**WWD DRAFT GSP
Comments and Questions
10/20/19**

RE: Support for the Draft Westside Subbasin Groundwater Sustainability Plan

**Figure 1 - Representative Monitoring Network for GW Levels Relative to Domestic Wells, DACs, and Community Water Systems
Westlands Water District GSA**

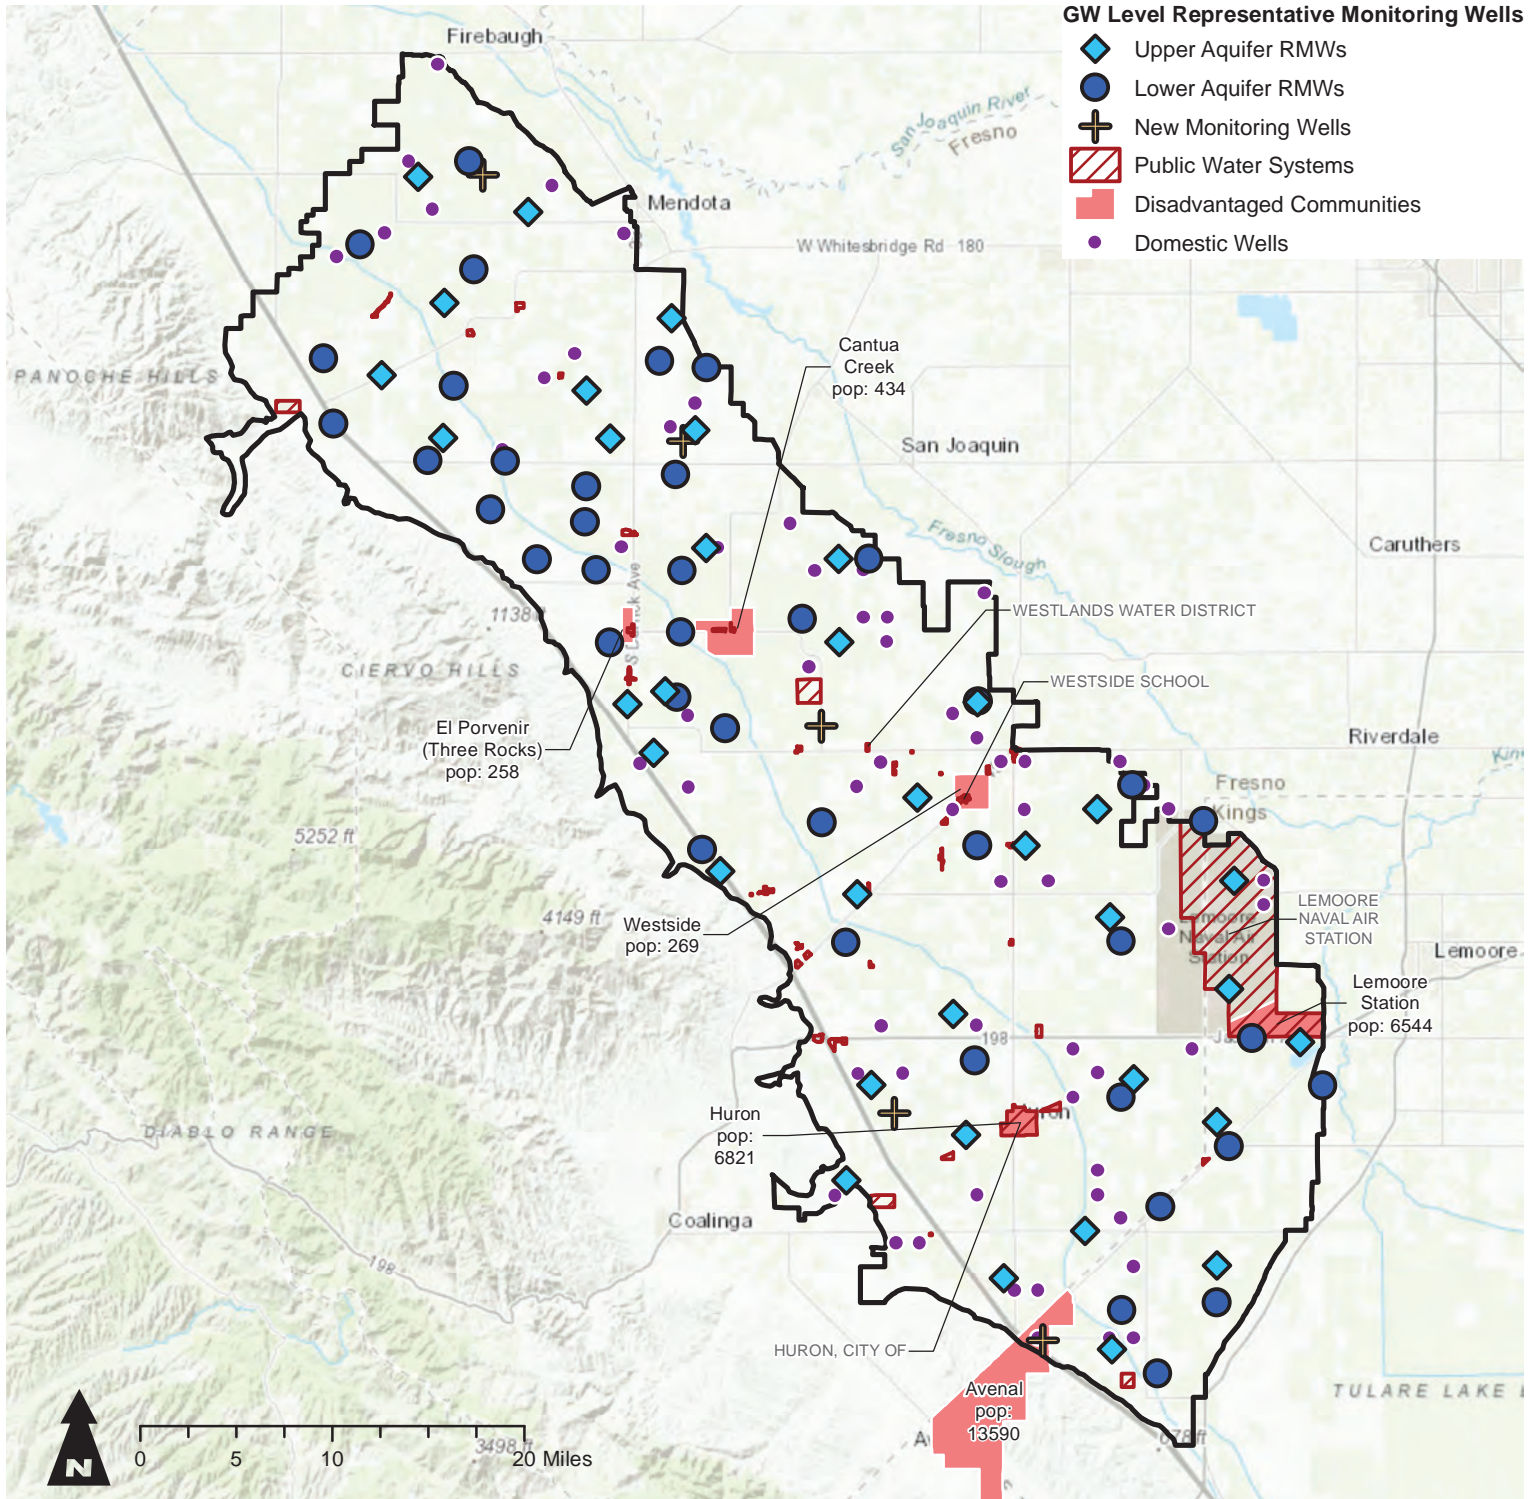
- As shown on **Figure 1**, the subbasin includes approximately 70 domestic wells¹ and six DWR-designated DACs² (i.e., Avenal, Huron, Cantua Creek, Lemoore Station, El Porvenir/Three Rocks, and Westside) with a collective population of over 27,900 people. The subbasin also includes 35 small water systems, including one school system, which collectively serve a population of over 25,100 people. It is noted that most of these systems rely on surface water delivered through the California Aqueduct; however, groundwater supply wells are currently being planned and/or developed for several communities including Cantua Creek, El Porvenir/Three Rocks, and Huron (Table 2-4 of draft GSP), in addition to the three public supply wells indicated in Figure 2-5 of the draft GSP. The Sustainable Groundwater Management Act (SGMA) requires the GSA to consider how the MTs “may affect the interests of beneficial uses and users of groundwater or land uses and property interests” (23 CCR § 354.28). The draft GSP states “Domestic users of groundwater are not expected to be impacted by the minimum thresholds since those thresholds have already been experienced historical. Lack of groundwater availability for domestic water uses in the Subbasin during the last drought as a result of declining groundwater levels was not reported.” (Section 3.3.9). Beyond this anecdotal evidence, the draft GSP does not provide data to determine if domestic wells were impacted (dewatered) during historical drought conditions. **The GSP should clearly describe how the proposed approach to developing MOs/MTs is protective of the drinking water users in the subbasin.**

- As shown on **Figure 1**, the water level monitoring network generally provides good coverage across the subbasin, with the exception of the areas near Calflax and Huron. Although the community water systems near Calflax and Huron rely on California Aqueduct water, the draft GSP lists the City of Huron as a potential groundwater extractor (Table 2-4). Therefore, future water level monitoring will be important near Huron as well. Additionally, the draft GSP acknowledges water level monitoring network spatial data gaps in Section 3.8.9.3 “Specifically, in the Upper Aquifer, the northern portion of the Subbasin along the northern and western boundary is lacking in monitoring

**Figure 2A - Estimated Water Level Decline at Measurable Objectives and Domestic Wells
Westlands Water District GSA**

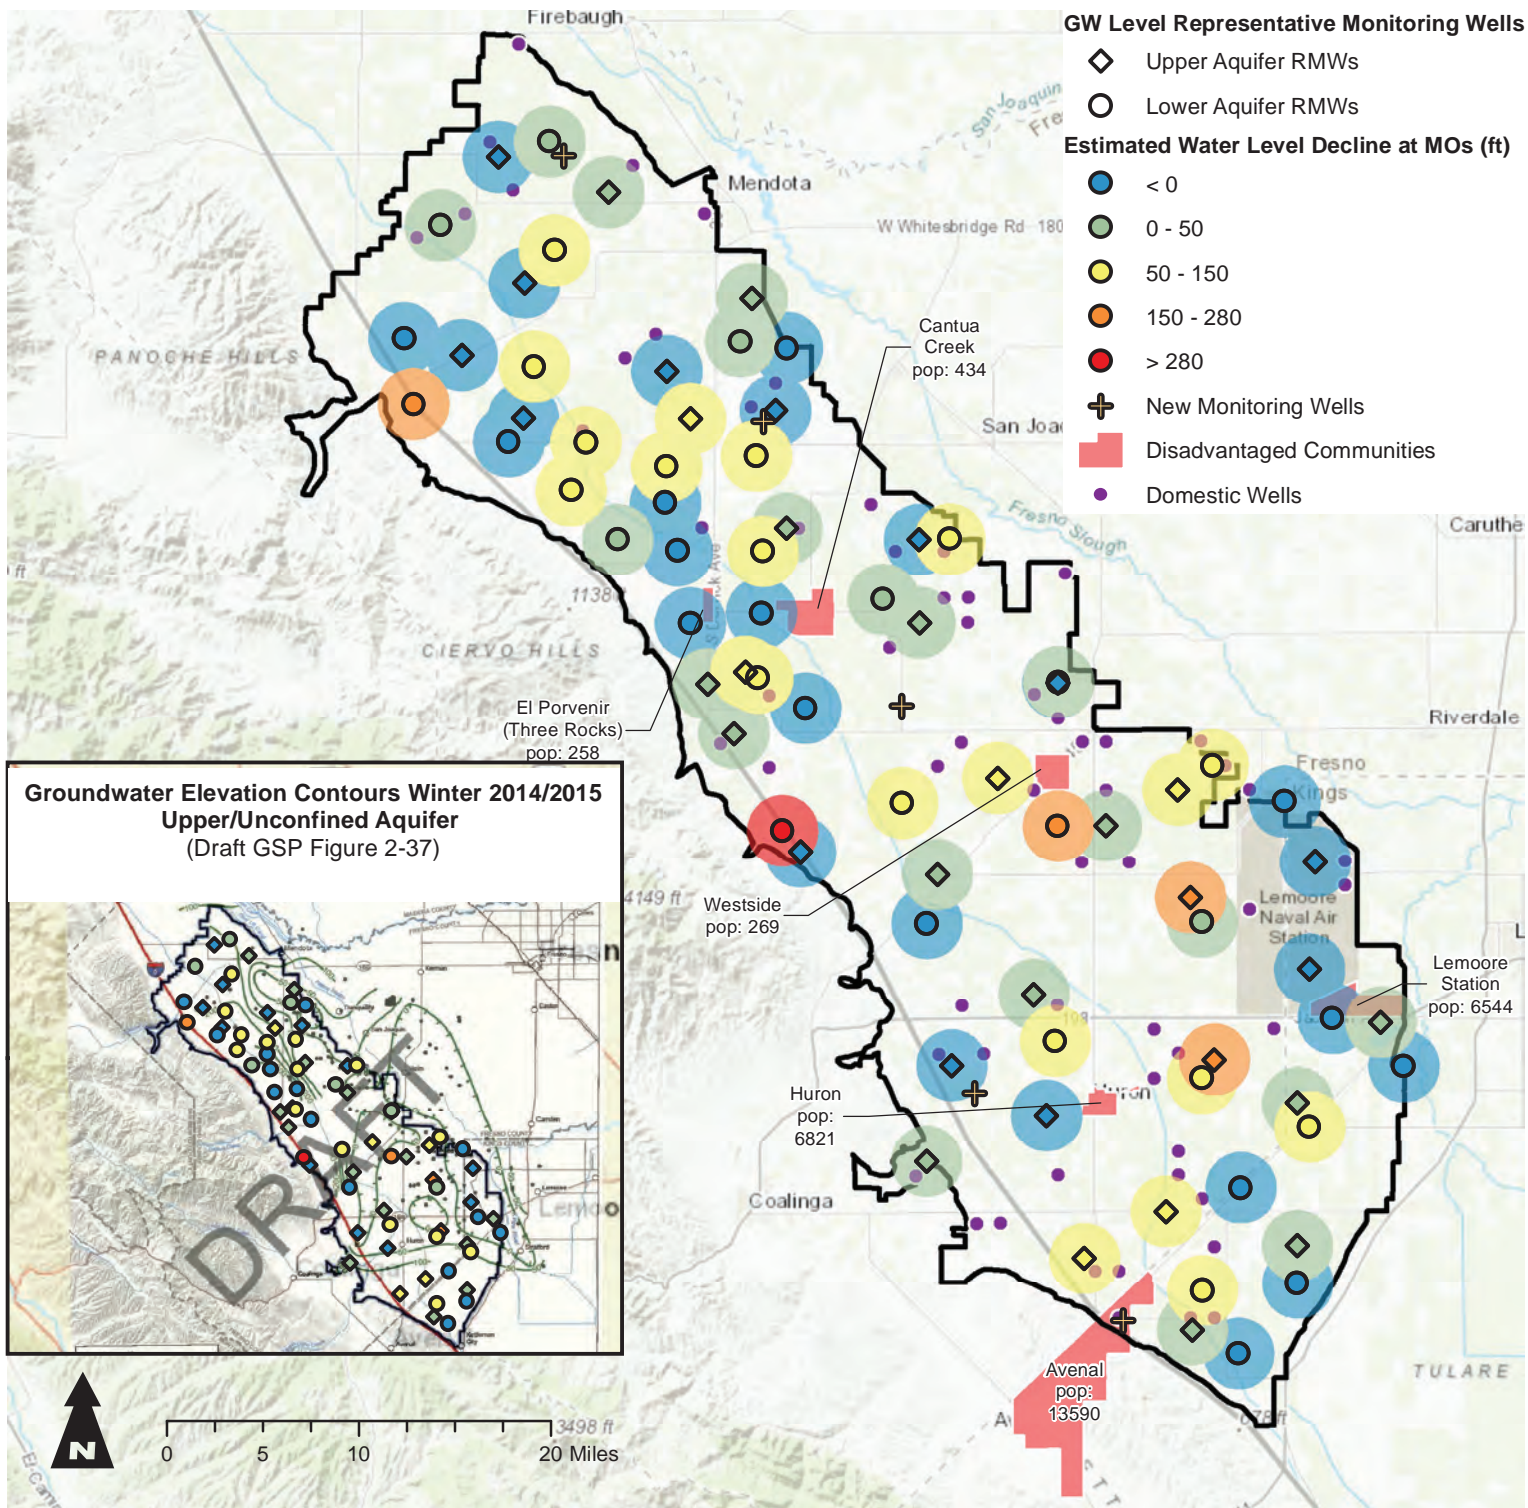
- Figures 2A and 2B** show the estimated water decline from current conditions that would occur at each RMW if water levels reach the MOs and MTs, respectively. At the MOs, the water levels would drop by an average of approximately 37 feet in the RMWs (**Figure 2A**); and at the MTs, the water levels would drop by an average of approximately 92 feet from current (2017) conditions (**Figure 2B**). **Table 1** below identifies selected RMWs located near DACs in the subbasin, the water level MOs and MTs, and the estimated water level decline from current conditions that is expected at the RMWs. The groundwater level MTs in the vicinity of these communities are an average of approximately 80 feet lower than current conditions. Given that the draft GSP has identified that Fresno County is in the process of installing municipal supply wells for both Cantua Creek and El Porvenir, **the GSAs should clearly communicate to the County the projected water level changes to the MOs and MTs in these areas. The GSP should consider and quantify both the potential dewatering of domestic wells and the increased pumping costs associated with the increased lift at the projected lower water levels, in order to more fully and transparently consider the impacts to beneficial users.**

- The insets in **Figures 2A** and **2B** also show the estimated water level declines at the RMWs overlaid on the draft GSP spring 2015 groundwater elevation contour map for the Upper Aquifer (draft GSP Figure 2-37). As identified above, water levels at all 75 RMWs would be expected to decline an average of 37 feet below current water levels (2017) if the MOs are reached and 92 feet if the MTs are reached. However, as shown on **Figure 2B**, the amount of decline is not consistent throughout the subbasin. For example, water levels would be expected to decline as much as 164 feet at the MO and 219 feet at the MT at RMW 18S/17E-09P01 near Westside (a DAC), but increase 32 feet at the MO and 10 feet at the MT at RMW 16S/15E-32A06 near Cantua Creek (also a DAC). If groundwater levels are managed to the MOs, this may result in changes to the overall groundwater direction gradients, which could potentially result in changes to water quality.³ **Therefore, it is recommended that the impacts to groundwater gradients at the proposed MOs and MTs be analyzed and described in the GSP, as well as impacts to drinking water wells.**

Figure 3 - Water Level Minimum Thresholds and Domestic Wells
Westlands Water District GSA

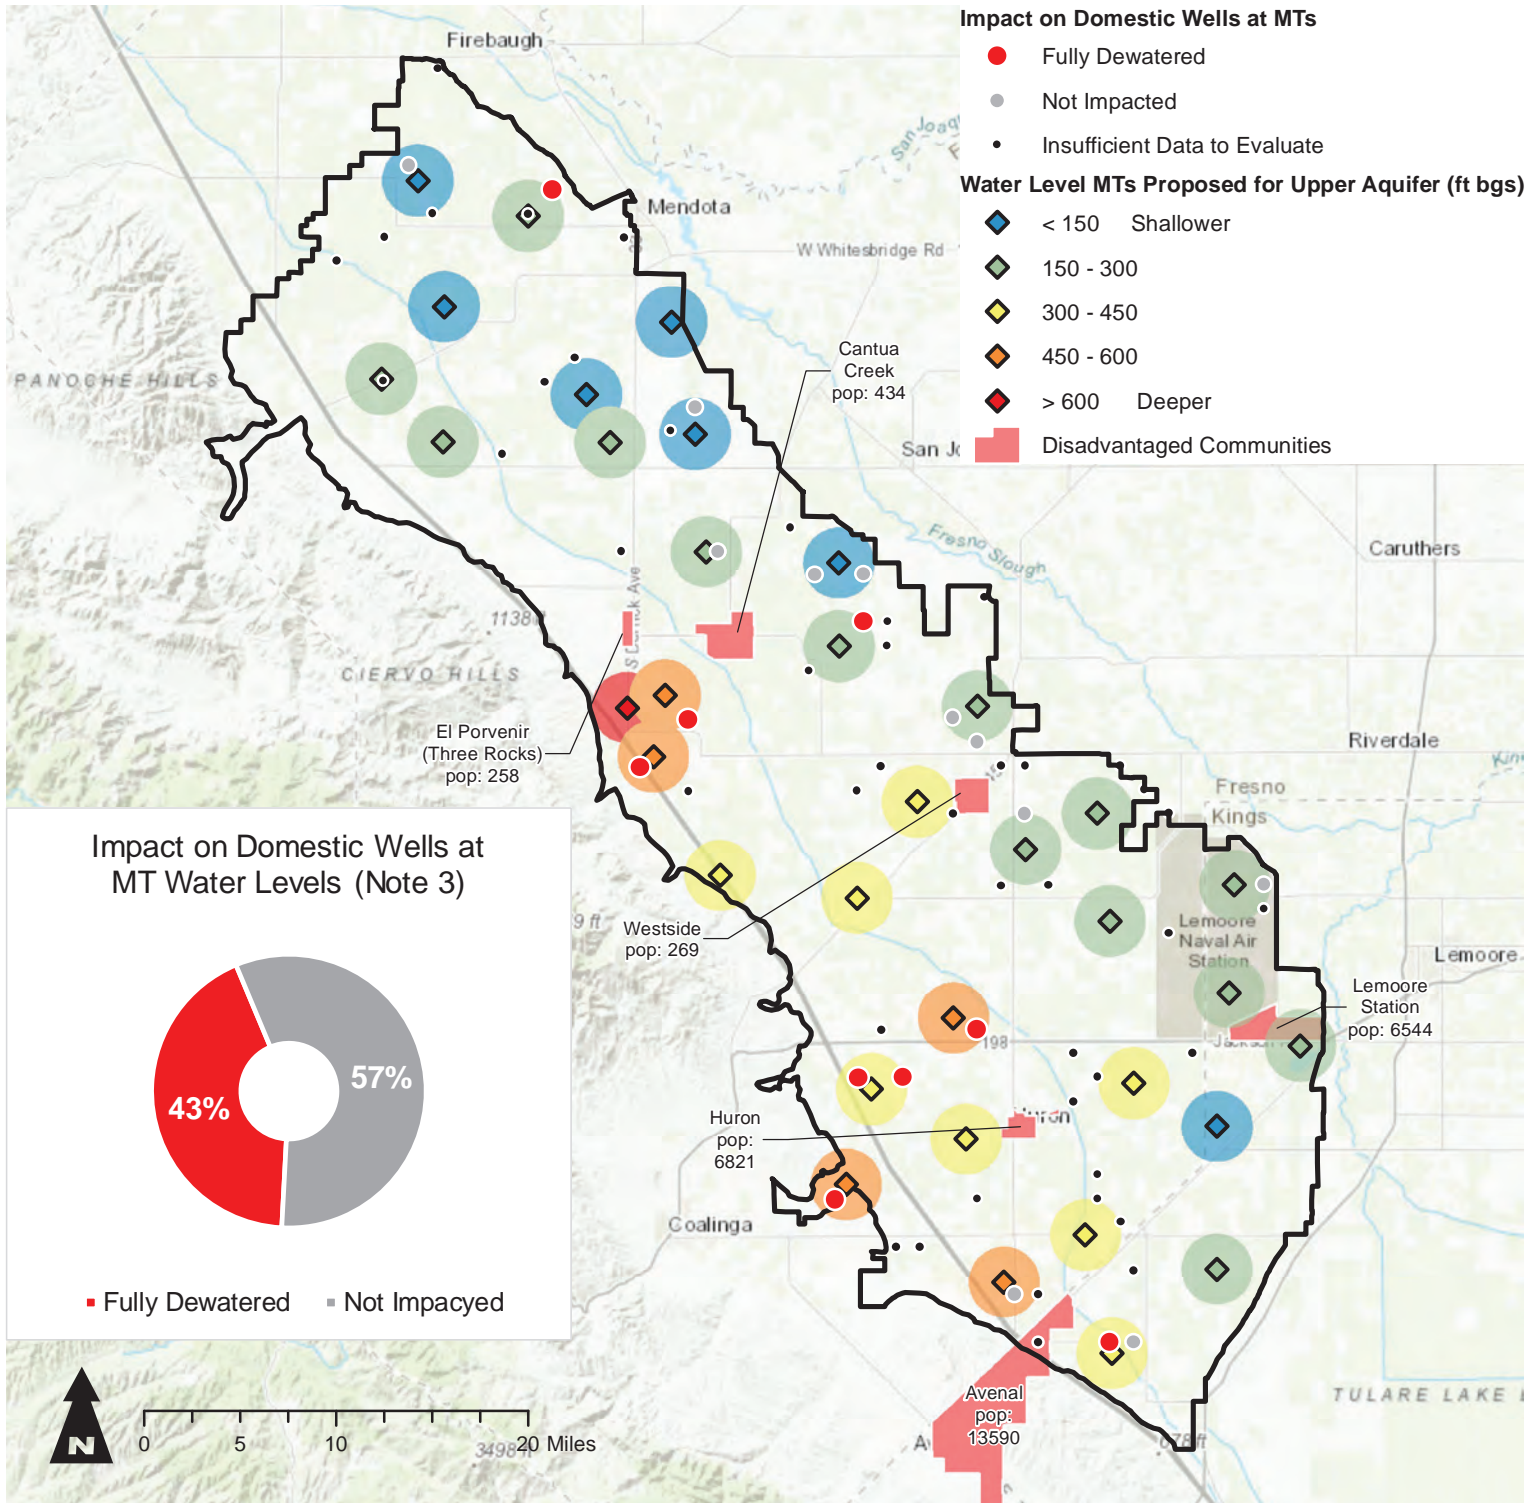
- **Figure 3** shows the approximate locations of domestic wells and Upper Aquifer water level RMWs within the subbasin. Since most domestic wells have relatively shallow well depths, they are assumed to primarily be screened within the Upper Aquifer and therefore only compared with MTs assigned for Upper Aquifer RMWs. This is consistent with the draft GSP which states “Based on knowledge of domestic wells located in the Subbasin, most domestic wells are constructed in the Upper Aquifer” (Section 2.2.2.2). For purposes of this evaluation, a 1.5-mile radius is shown around each RMW. Based on available well construction information, the well screens of the domestic wells located within this 1.5-mile radius are compared to the proposed MTs for the RMWs. For purposes of this assessment, a well is identified as fully dewatered if the MT is below or at the bottom of the well screen interval and a well is identified as partially dewatered if the MT is below or at the midpoint of the well screen interval. Approximately 33% of domestic wells in the subbasin are located within the 1.5-mile radius of RMWs. When water levels reach MTs, approximately 43% of these domestic wells would be expected to be fully dewatered. We acknowledge that, according to the draft GSP (Section 2.1.3), not all of these domestic wells are currently active. However, based on the available information in the draft GSP, we are not able to distinguish the status of these domestic wells in the available dataset. We also acknowledge that this is a “quick and dirty” assessment of domestic well impacts, and therefore **recommend that the GSP present a thorough and robust analysis, supported by maps, that identifies: (1) which active domestic wells are likely to be impacted (including partially dewatered) at the MTs and at the MOs, and (2) the location of the likely impacted wells with respect to DACs and other communities and water systems dependent on groundwater.**
